**RE: AIRPORT LAND USE COMMISSION (ALUC) DEVELOPMENT REVIEW –
DIRECTOR’S DETERMINATION**

File No.: ZAP1304MA18 (letter 1 of 2)
Related File No.: P18-0028 (Rezone)
APN: not assigned yet

File No.: ZAP1304MA18 (letter 2 of 2)
Related File No.: P18-0031 and P18-0032 (Conditional Use Permits), P18-0033 (Design Review), P18-0034 (Tentative Parcel Map No. 37591)
APN: not assigned yet

Under the delegation of the Riverside County Airport Land Use Commission (ALUC) pursuant to Policy 1.5.2(d) of the Countywide Policies of the 2004 Riverside County Airport Land Use Compatibility Plan, staff reviewed City of Riverside Case Nos. P18-0031 and P18-0032 (Conditional Use Permits) and P18-0033 (Design Review) proposing to establish a 12-pump gas station with a 3,200 square foot convenience store, a 1,199 square foot automated car wash facility, and a 3,800 square foot drive-thru fast food restaurant on 2.2 acres located on the northeast corner of Central Avenue and Sycamore Canyon Boulevard and P18-0034 (Tentative Parcel Map No. 37591), a proposal to divide the 2.2 acre site into 2 commercial parcels.

SITE PLAN
1" = 30' 0"

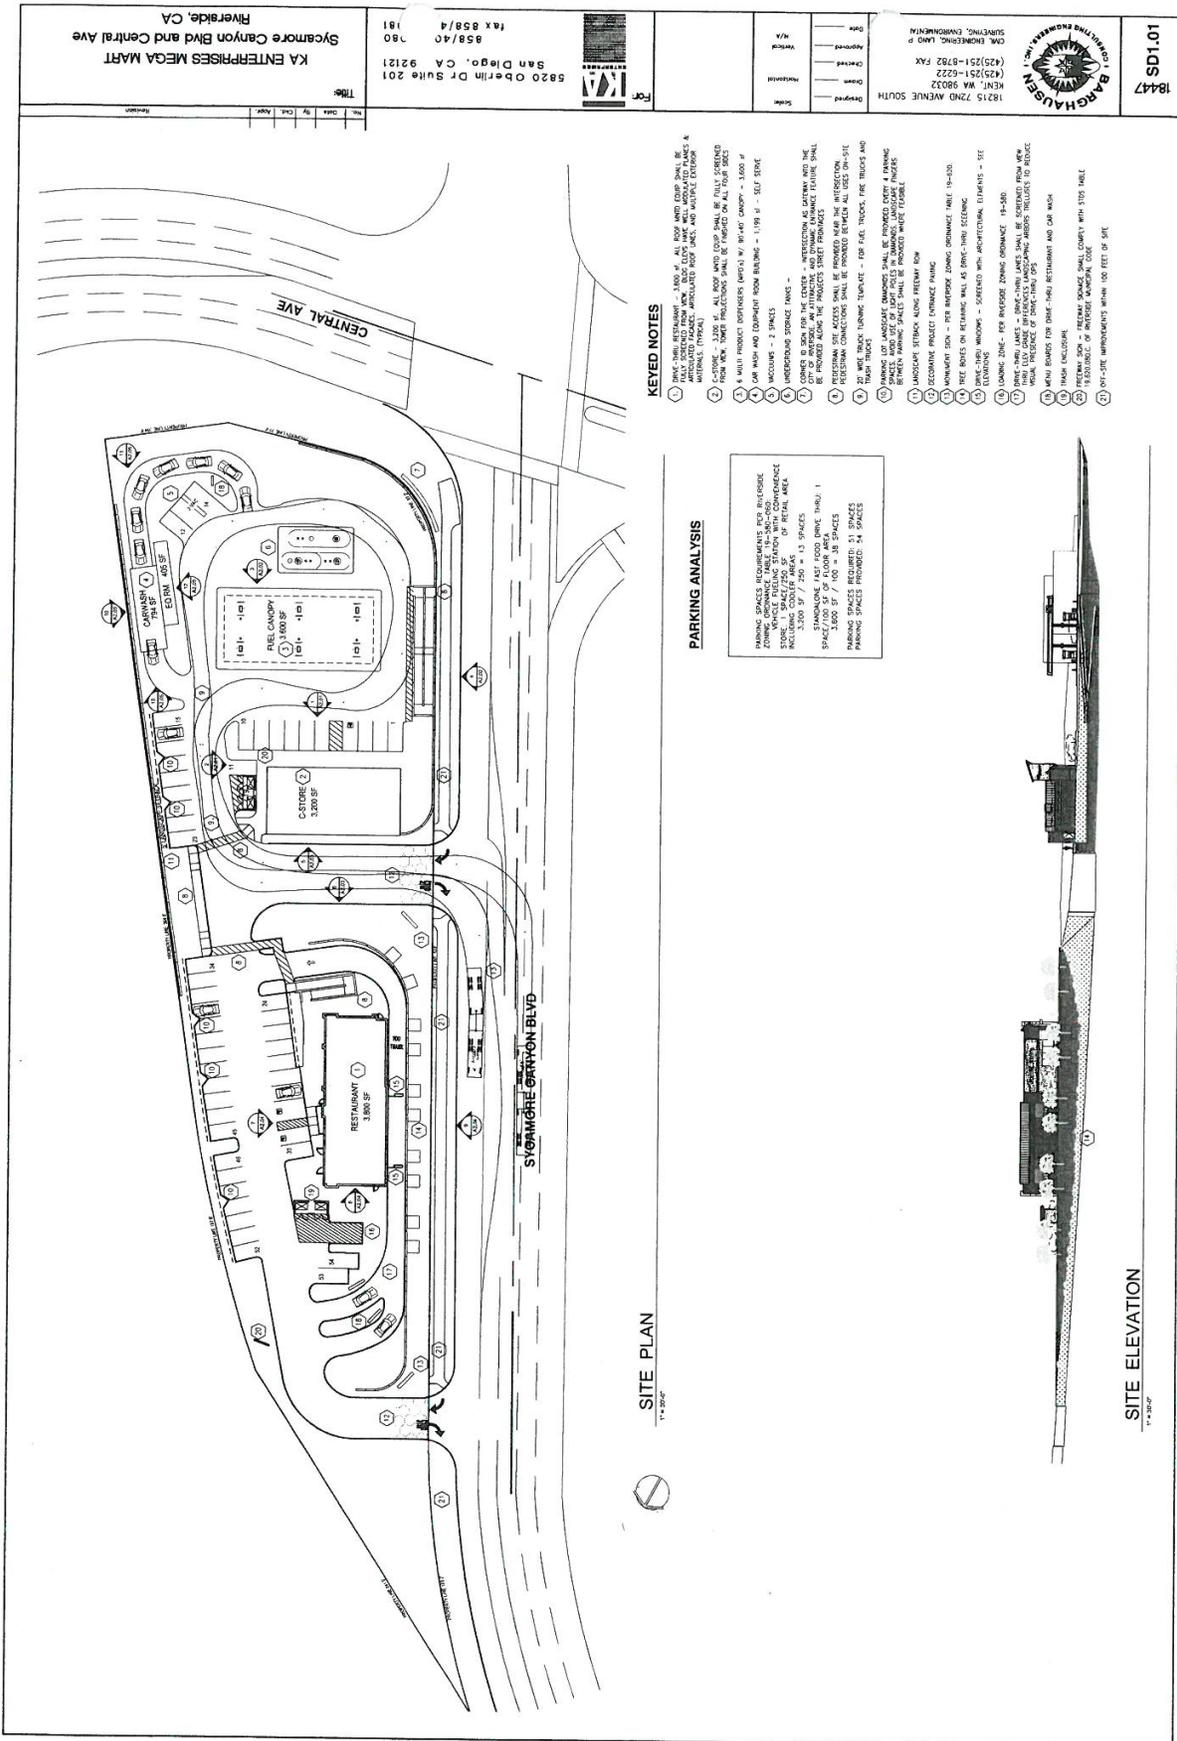
4. No detention basins are depicted on the site plan. Any new aboveground detention or water quality basins on the site shall be designed so as to provide for a maximum 48-hour detention period following the conclusion of the storm event for the design storm (may be less, but not more), and to remain totally dry between rainfalls. Vegetation in and around the detention/water quality basin(s) that would provide food or cover for bird species that would be incompatible with airport operations shall not be utilized in project landscaping.
